Committee of Experts on the Transport of Dangerous Goods and on the Globally Harmonized System of Classification and Labelling of Chemicals

**Miscellaneous proposals for amendments to the Model Regulations
on the Transport of Dangerous Goods: other miscellaneous proposals**

Comments on document ST/SG/AC.10/C.3/2017/21 Proposal of amendment to section 5.5.3

Transmitted by the expert from Austria

Figure 5.5.2

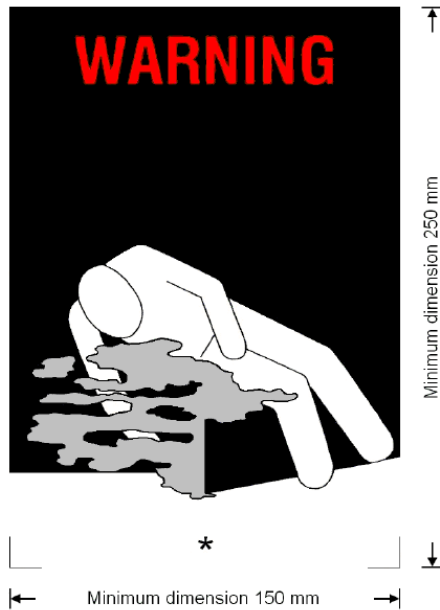
2. Document 21 deals with the addition of “protection” as reason for the application of an asphyxiating gas. Therefore the proposal is to add to the two versions of figure 5.5.2 with “AS COOLANT” and “AS CONDITIONER” an additional version with “AS PROTECTIVE AGENT”. That means that additional versions of the figure have to be printed and made available.

3. The warning mark is used to inform that inside the cargo transport unit is an asphyxiate atmosphere, it does not matter if it for cooling, conditioning, or protection purposes! The resulting measures will be exactly the same in all these cases.

4. Therefore we propose an even simpler solution as in document 21 for the footnote to figure 5.5.2 and that is to eliminate the double asterix and the text for it under the figure.

Eliminate the double asterix in the figure and the corresponding text for it under the figure to read 5.5.6.2 as follows.

5.5.3.6.2 The warning mark shall be as shown in Figure 5.5.2.

Coolant/conditioning/protective agent warning mark for cargo transport units

* Insert proper shipping name of the coolant/conditioner/protective agent. The lettering shall be in capitals, all be on one line and shall be at least 25 mm high. If the length of the proper shipping name is too long to fit in the space provided, the lettering may be reduced to the maximum size possible to fit. For example: CARBON DIOXIDE, SOLID.

The mark shall be a rectangle. The minimum dimensions shall be 150 mm wide × 250 mm high. The word "WARNING" shall be in red or white and be at least 25 mm high. Where dimensions are not specified, all features shall be in approximate proportion to those shown.
